WYOMING LIBRARY REMODEL

Job No. 6943.03

AS PER ADDENDUM #1

RECORD SET OF DRAWINGS

Add Panic Hardware

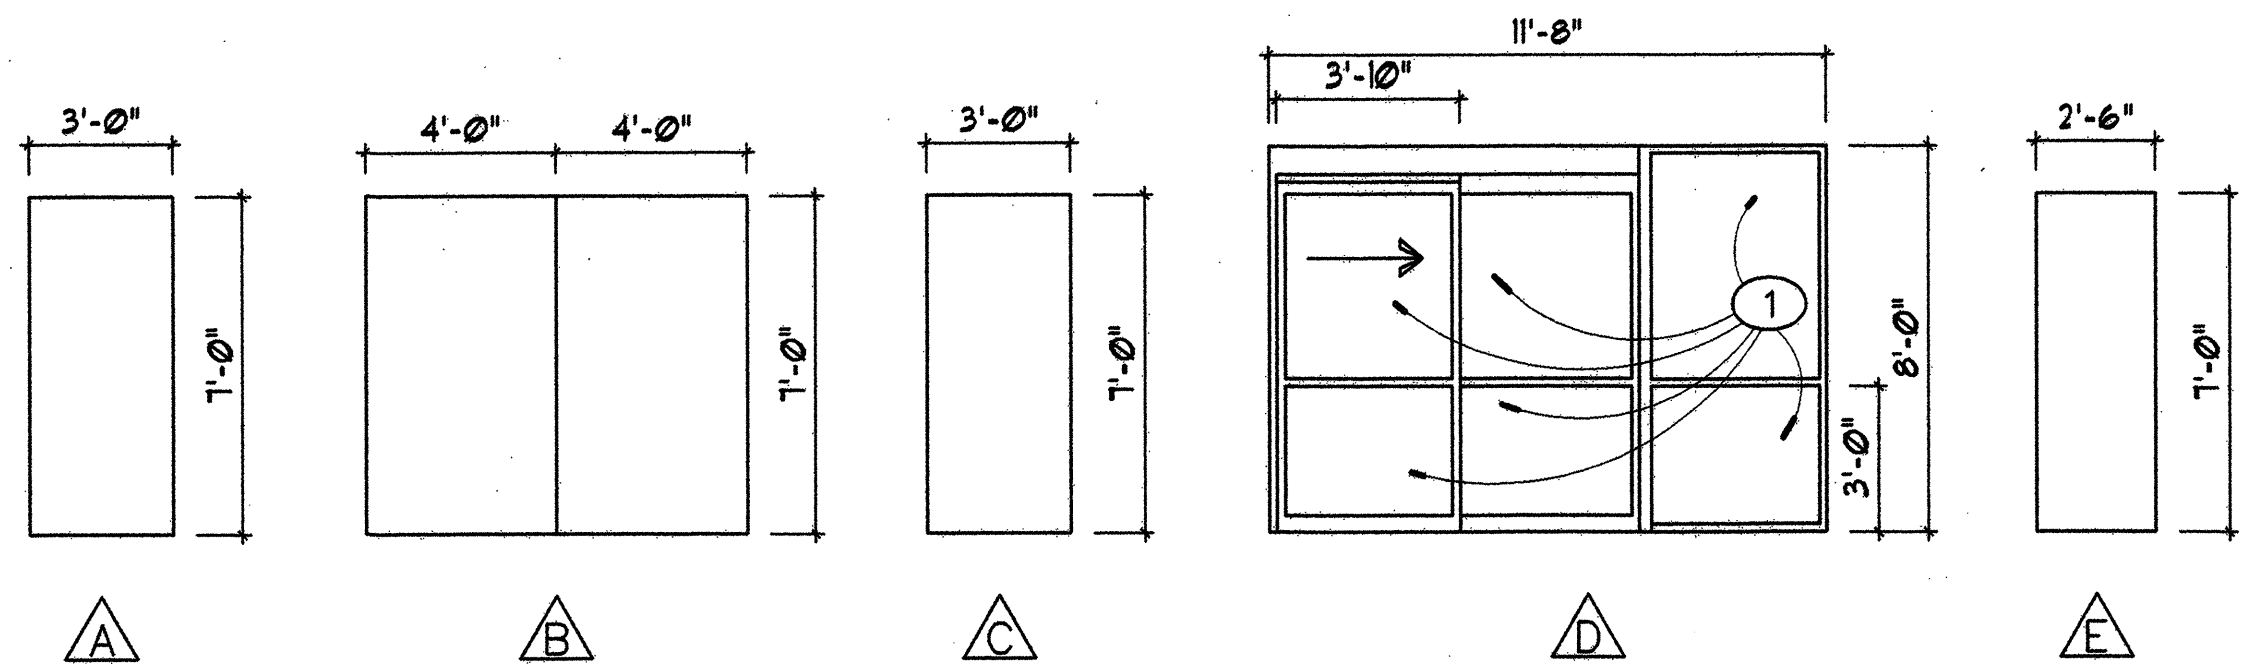
Please provide a price for adding the following hardware to Doors 123 & 127b, see attached Hardware Set 09. We want to reuse the existing doors to the patio, but will need to install new hardware.

Sheet A-101

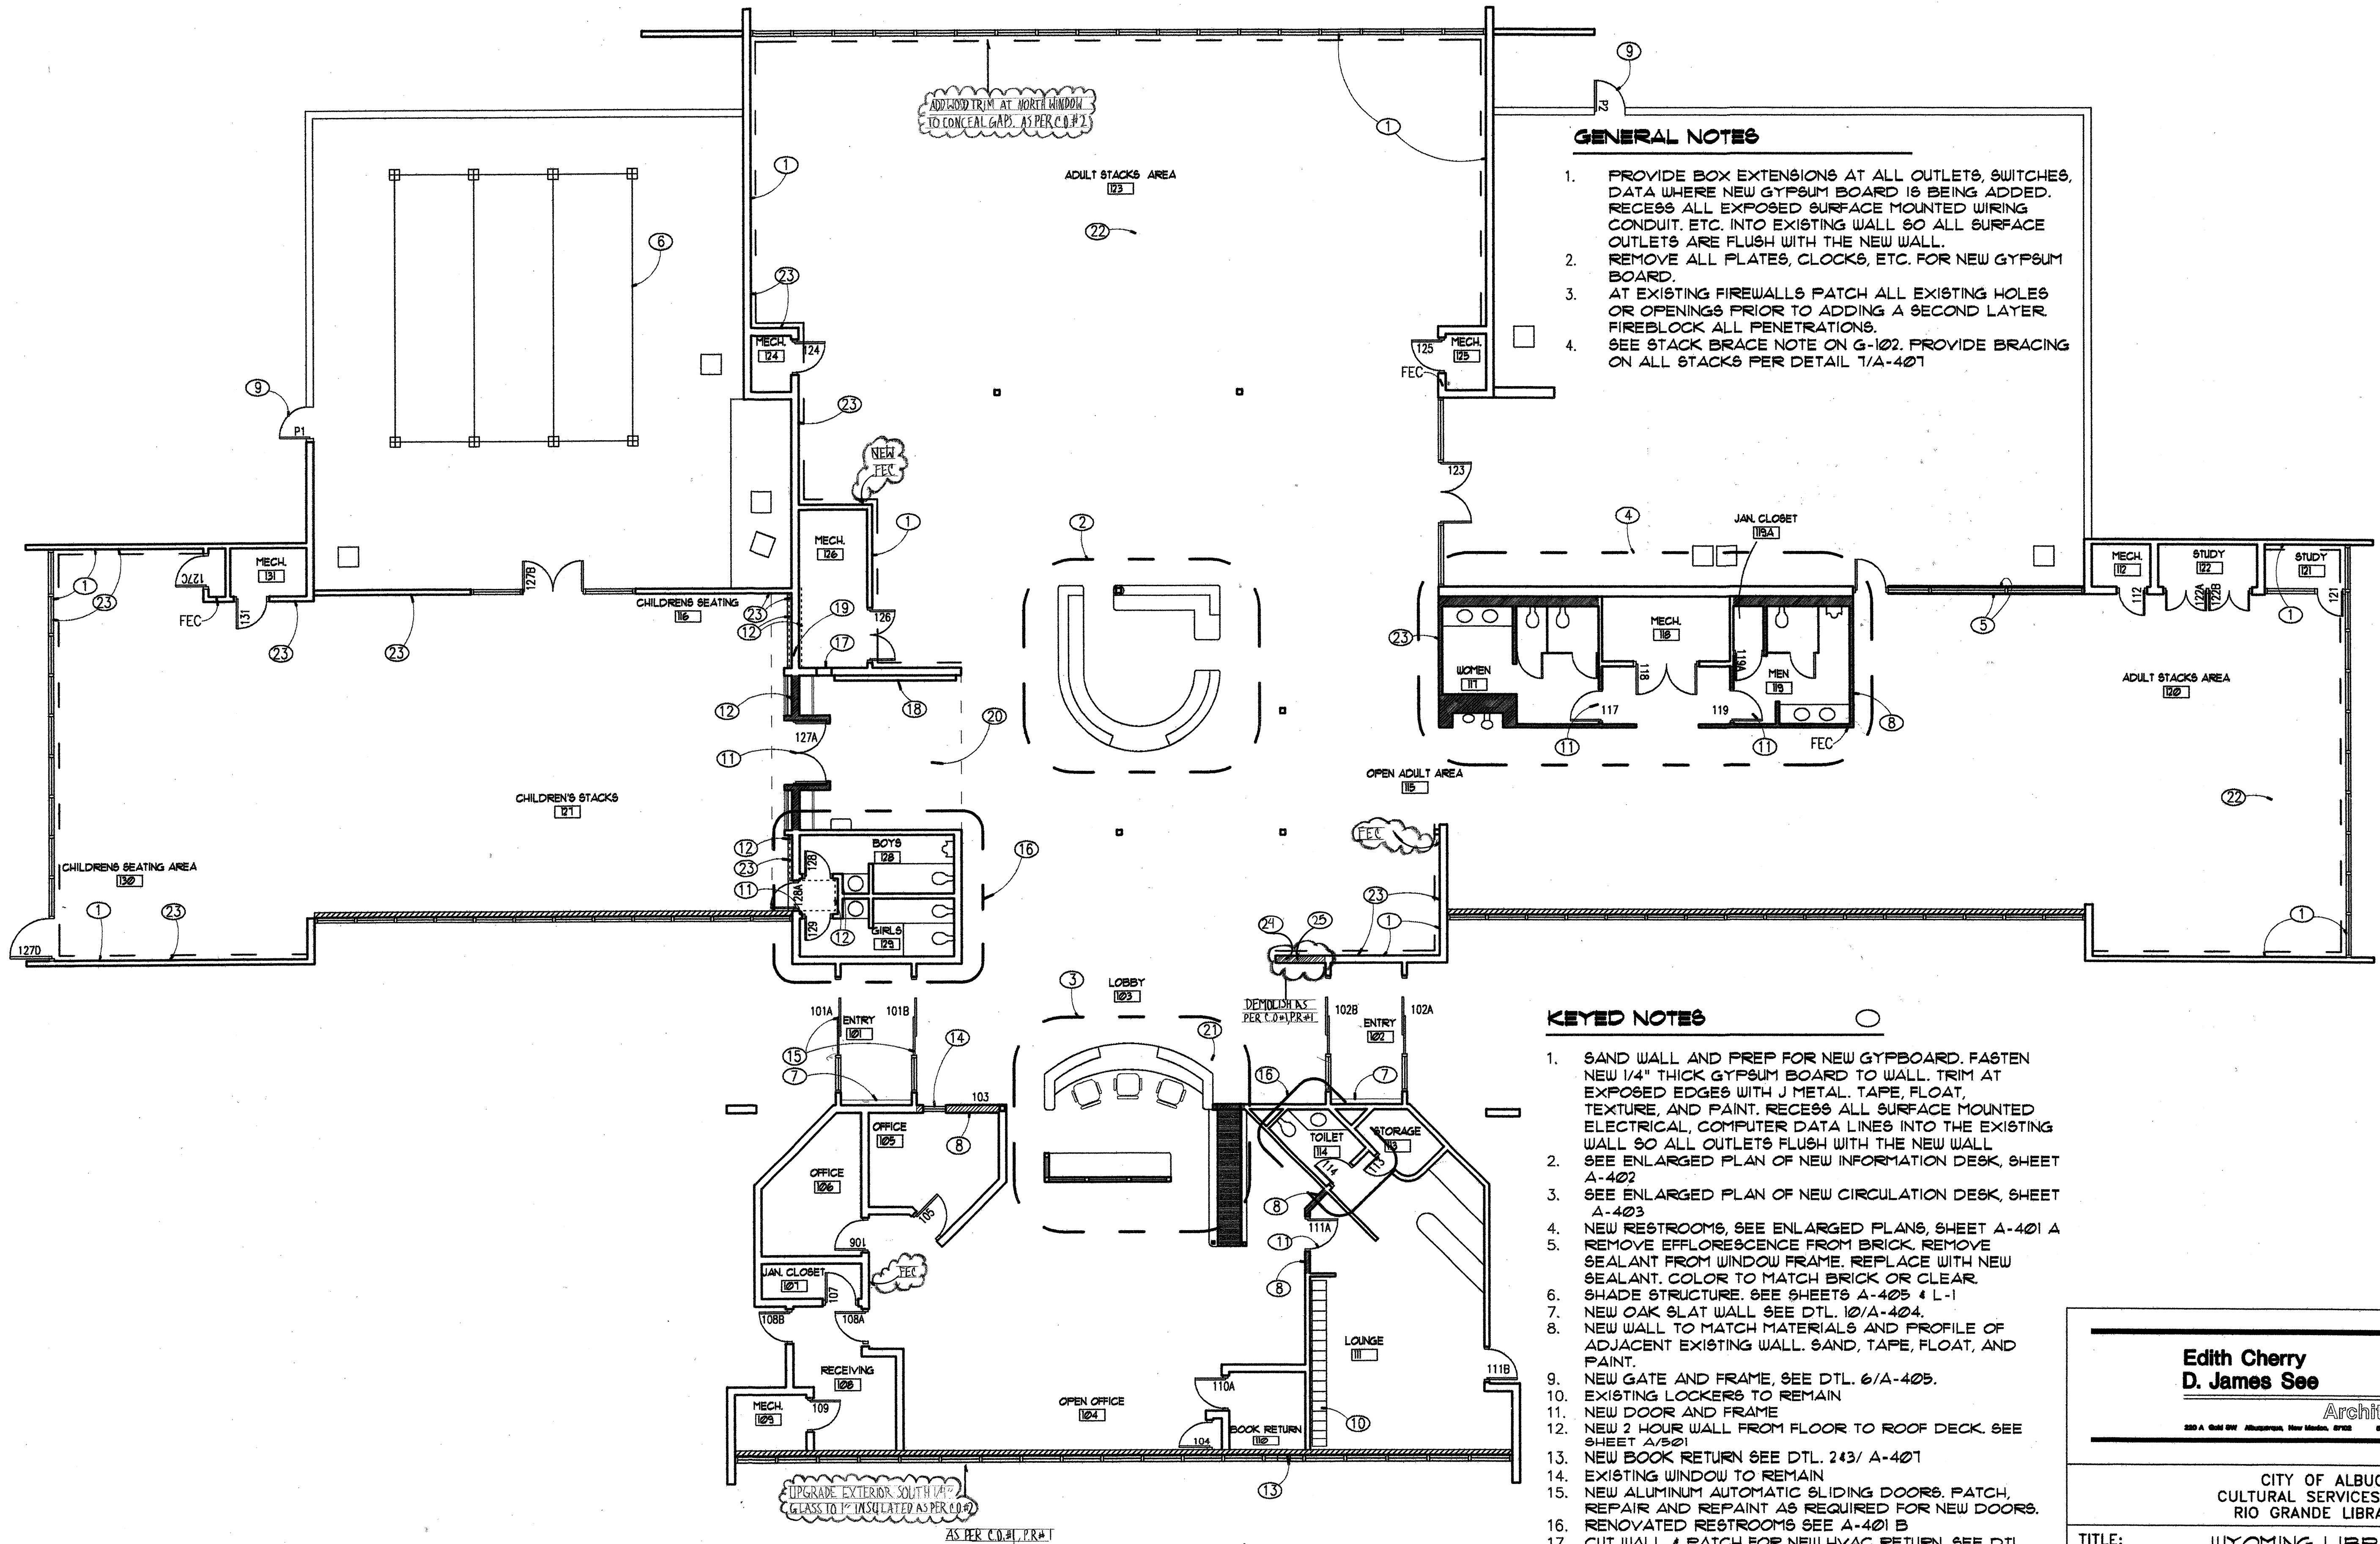
General Notes, Room Finish Schedule, Note No 2, clarification/modification: The existing carpet is carpet tiles. Any carpet tile removed for construction and not damaged may be reused. Upon completion of the project all carpeted areas are to be complete without missing carpet tile. If additional carpet tile is needed due to damage or insufficient quantities, it is to be provided by the contractor as part of the base bid. The additional carpet tile that is required has to match the existing material. The contact for the carpet tile is Warren Jefferies at Dimensions Floor Services 888-0066.

REFLECTED CEILING PLAN

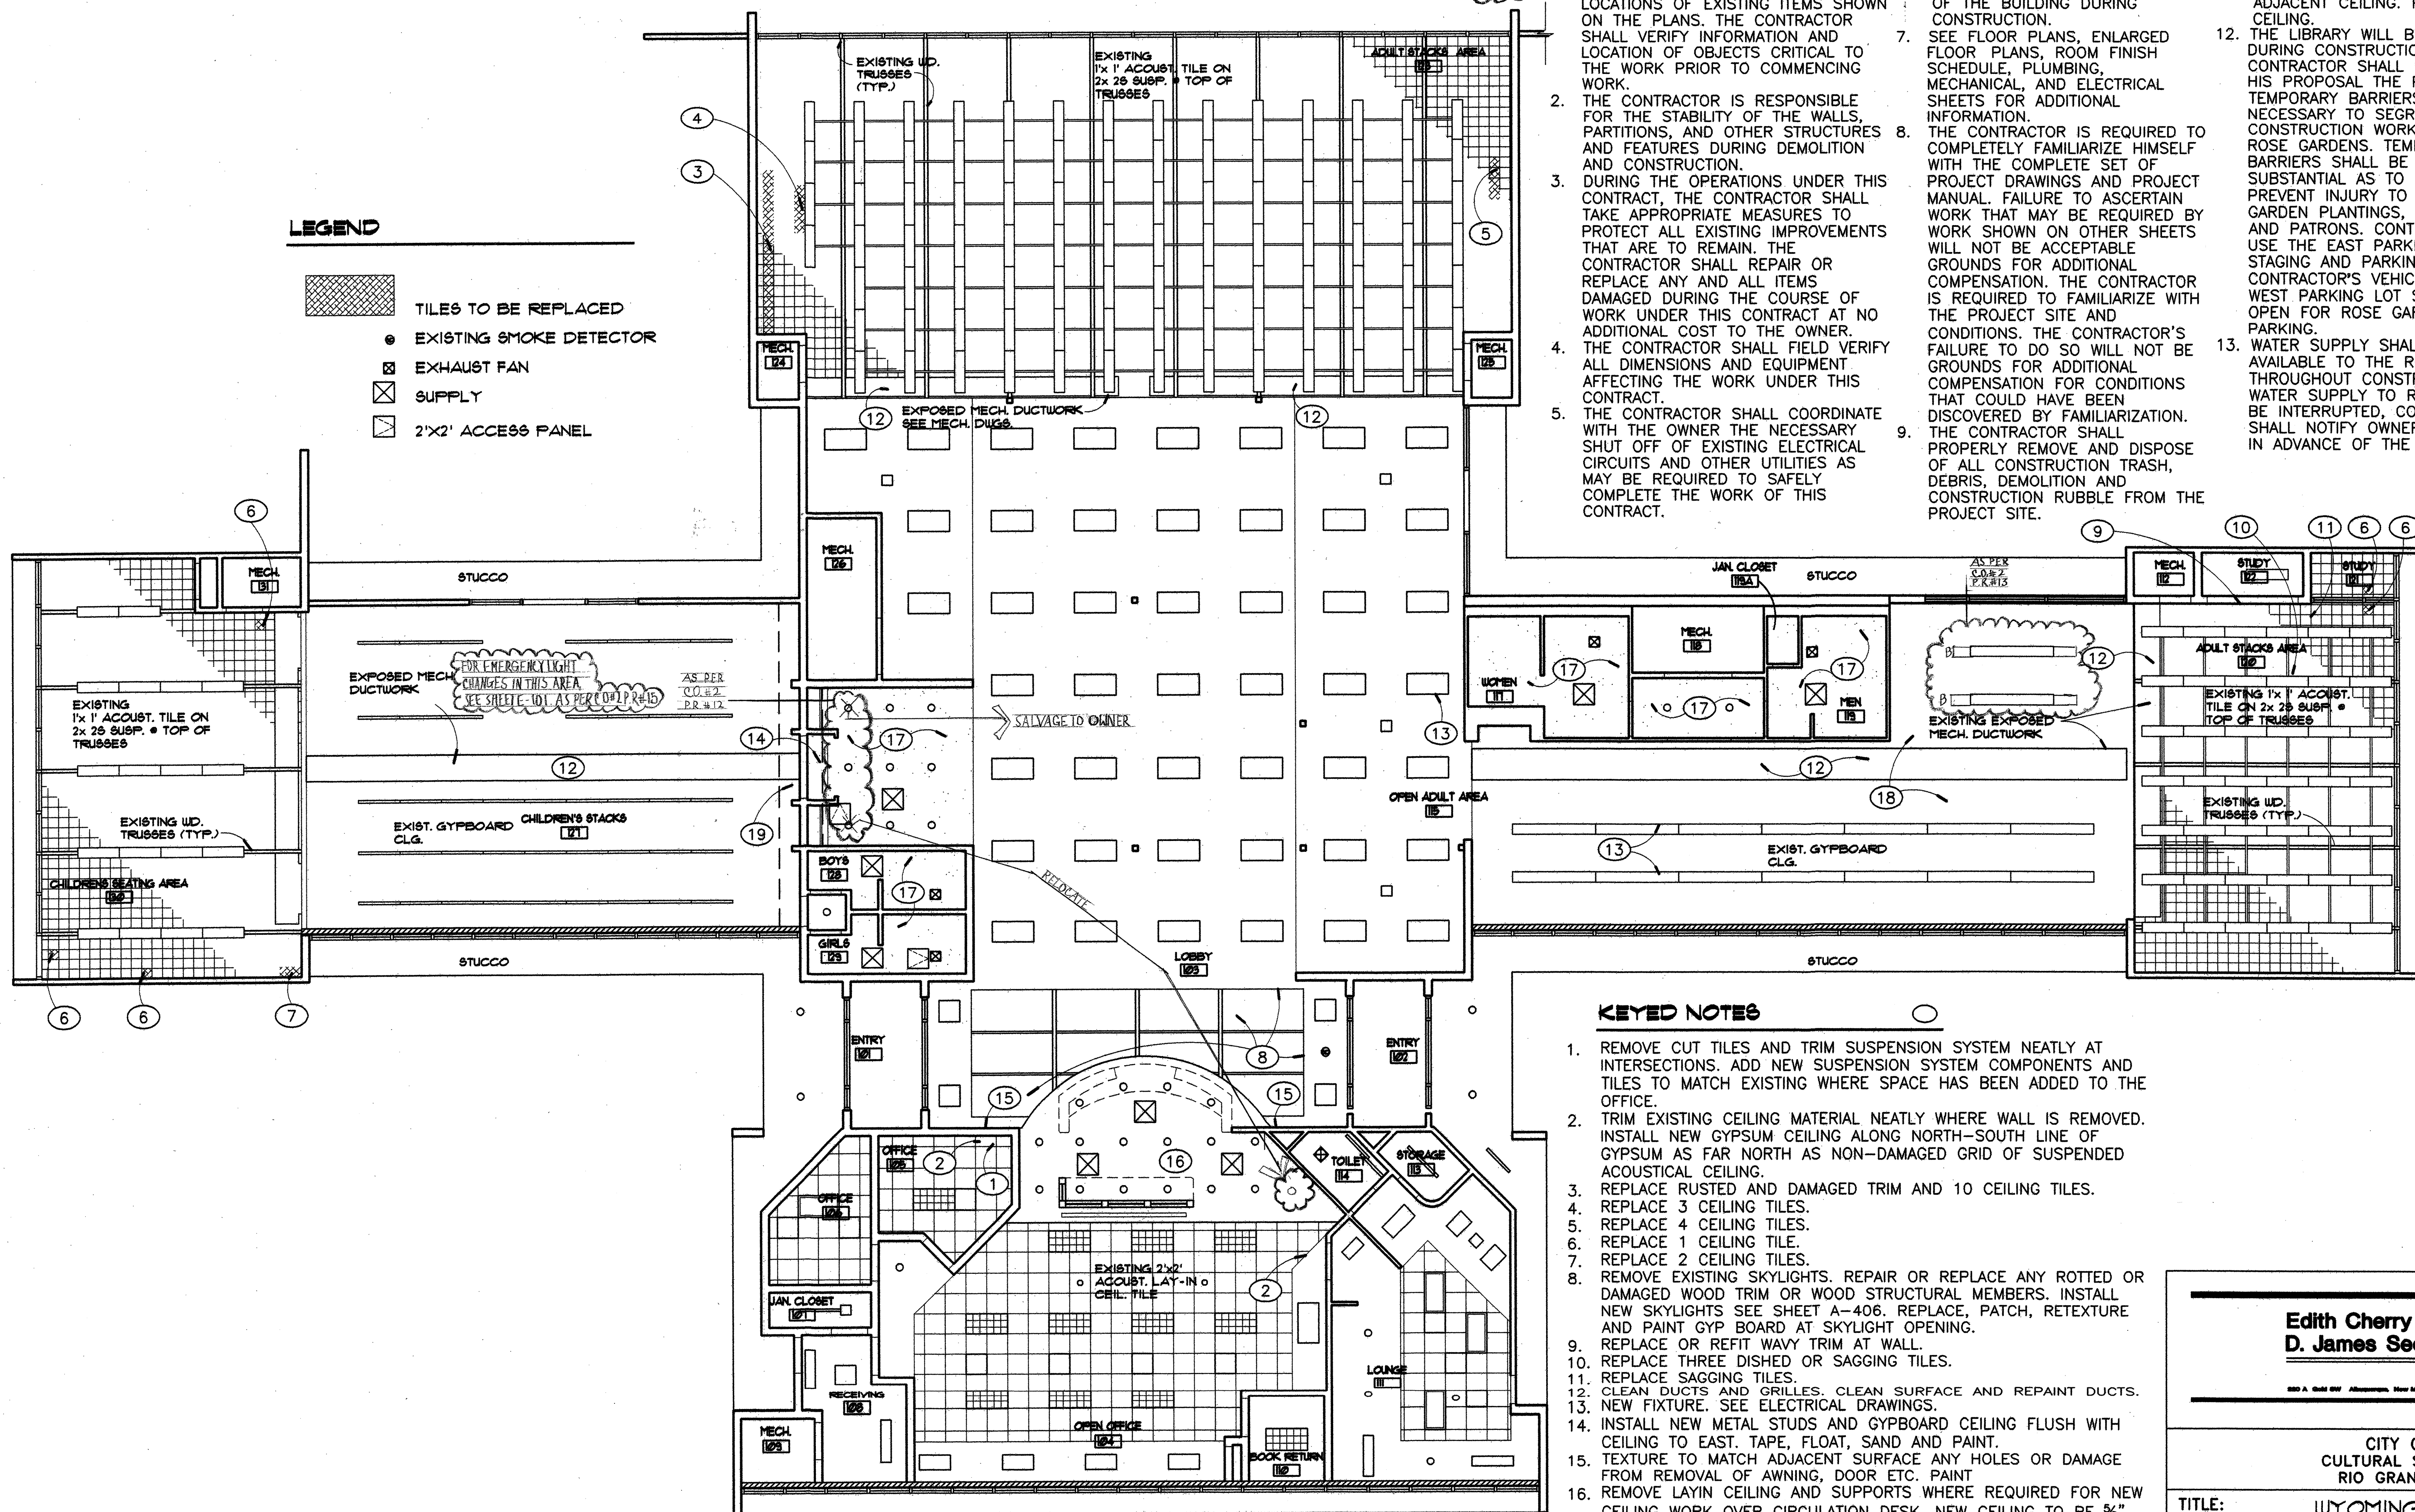
Sheet A-103
Add the ceiling hung sign noted in Keyed Note 21 on Sheet A-301 over the circulation desk. Add the ceiling hung signs noted in Keyed Note 23 on A-402 over the information desk. At the information desk final locations may have to be modified to fit the existing light fixtures.
